Point Beach Nuclear Plant, Units 1 and 2
Dockets 50-266 and 50-301

Subject: Response to Request for Additional Information Regarding License Amendment Request 287, Application to Adopt 10 CFR 50.69, "Risk informed Categorization and Treatment of Structures, System, and Components (SSCs) for Nuclear Power Plants"

Response to Request for Additional Information

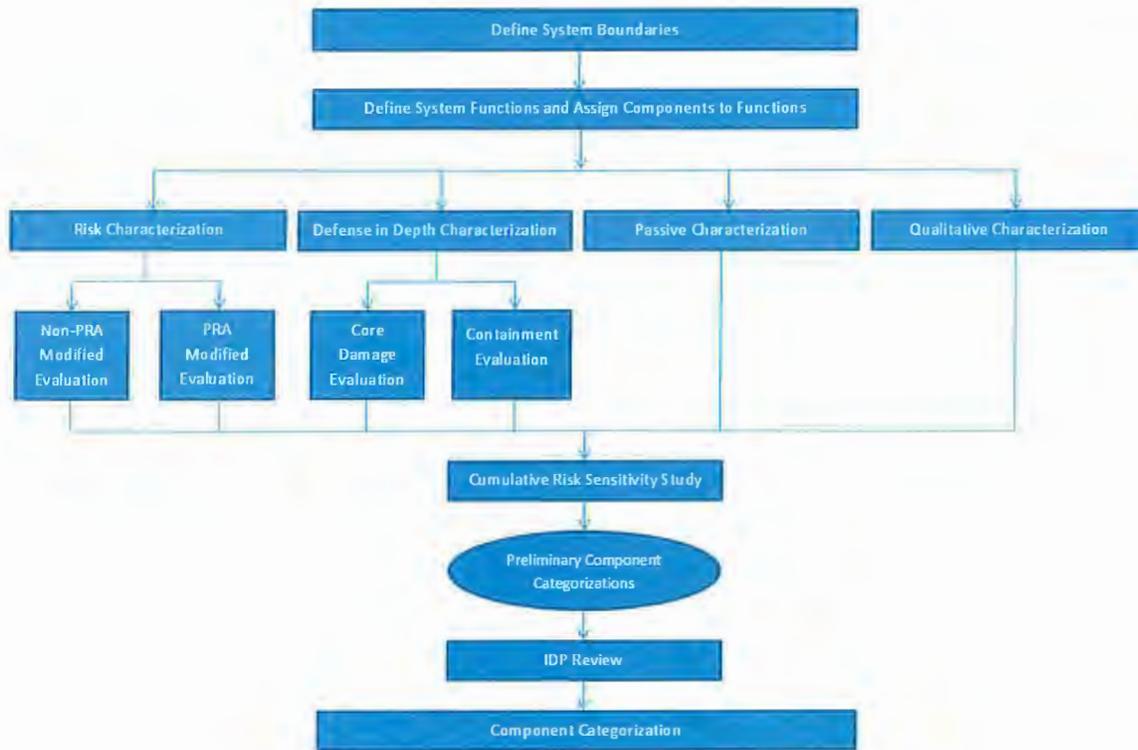
- a. Summarize, in the order they will be performed, the sequence of elements or steps that will be followed to categorize a respective system. A flow chart, such as that provided in the NEI presentation (ADAMS Accession Number ML17249A072) for the September 6, 2017, public meeting with NEI regarding 10 CFR 50.69 LARs (ADAMS Accession Number ML17265A020) may be provided instead of a description. The steps should include:
 - i. The input from all PRA evaluations such as use of the results from the internal events, internal flooding, seismic, and fire PRAs;
 - ii. The input from non-PRA approaches (other external events, and shutdown);
 - iii. The input from the responses to the seven qualitative questions in NEI 00-04, Section 9.2;
 - iv. The input from the defense-in-depth (DID) matrix;
 - v. The input from the passive categorization methodology.

a-c. The process to categorize each system will be consistent with the guidance in NEI 00-04, “10 CFR 50.69 SSC Categorization Guideline,” as endorsed by RG 1.201. RG 1.201 states that “the implementation of all processes described in NEI 00-04 (i.e., Sections 2 through 12) is integral to providing reasonable confidence” and that “all aspects of NEI 00-04 must be followed to achieve reasonable confidence in the evaluations required by §50.69(c)(1)(iv).” However, neither RG 1.201 nor NEI 00-04 prescribe a particular sequence or order for each of the elements to be completed. Therefore, the order in which each of the elements of the categorization process (listed below) is completed is flexible and as long as they are all completed; they may even be performed in parallel. Note that NEI 00-04 only requires Item 3 to be completed for components/functions categorized as LSS by all other elements. Similarly, NEI 00-04 only requires Item 4 to be completed for safety related active components/functions categorized as LSS by all other elements.

1. PRA-based evaluations (e.g., the internal events, internal flooding, and fire PRAs)
2. Non-PRA approaches (e.g., seismic safe shutdown equipment list (SSEL), other external events screening, and shutdown assessment)
3. Seven qualitative criteria in Section 9.2 of NEI 00-04
4. Defense-in-depth assessment
5. Passive categorization methodology

On the following page is an example of the major steps of the categorization process described in NEI 00-04.

Categorization of SSCs will be completed per the NEI 00-04 process, as endorsed by RG 1.201, which includes the determination of safety significance through the various elements identified above. The results of these elements are used as inputs to arrive at a preliminary component categorization (i.e., High Safety Significant (HSS) or Low Safety Significant (LSS)) that is presented to the Integrated Decision-Making Panel (IDP). Note: the term “preliminary HSS or LSS” is synonymous with the NEI 00-04 term “candidate HSS or LSS.” A component or function is preliminarily categorized as HSS if any element of the process results in a preliminary HSS determination in accordance with Table 1 below. The safety significance determination of each element, identified above, is independent of each other, and therefore the sequence of the elements does not impact the resulting preliminary categorization of each component or function. Consistent with NEI 00-04, the categorization of a component or function will only be “preliminary” until it has been confirmed by the IDP. Once the IDP confirms that the categorization process was followed appropriately, the final Risk Informed Safety Class (RISC) category can be assigned.
